10-12-23 - Initial Redlines -JJ

PLAN 5 THE APEX - LH 'CRAFTSMAN'

Lot 36 WS- 65 Willow Creek Place, Fuquay-Varina, NC 27526

PLAN 5 - THE APEX - LH
SINGLE FAMILY
Cover Sheet 'Craftsman'

SHEET
2.1c

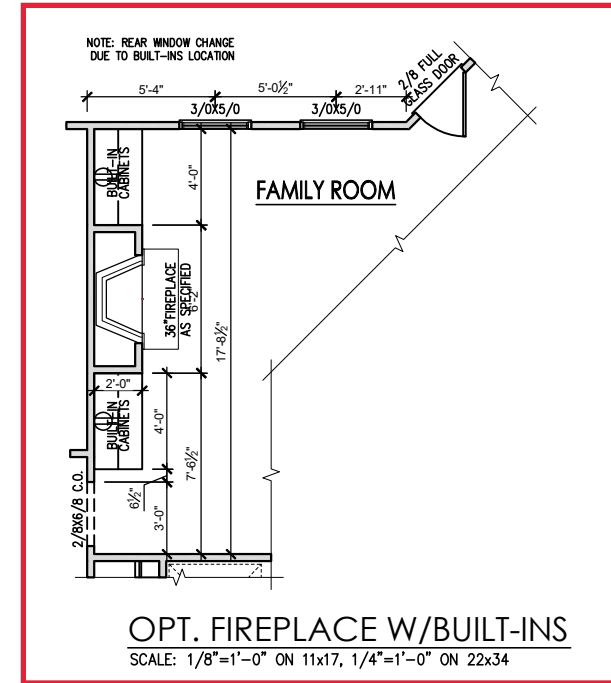
3 3/0 x 5/0
Windows no
Grids

Include windows

See Sheet
2.1.1c

Include windows
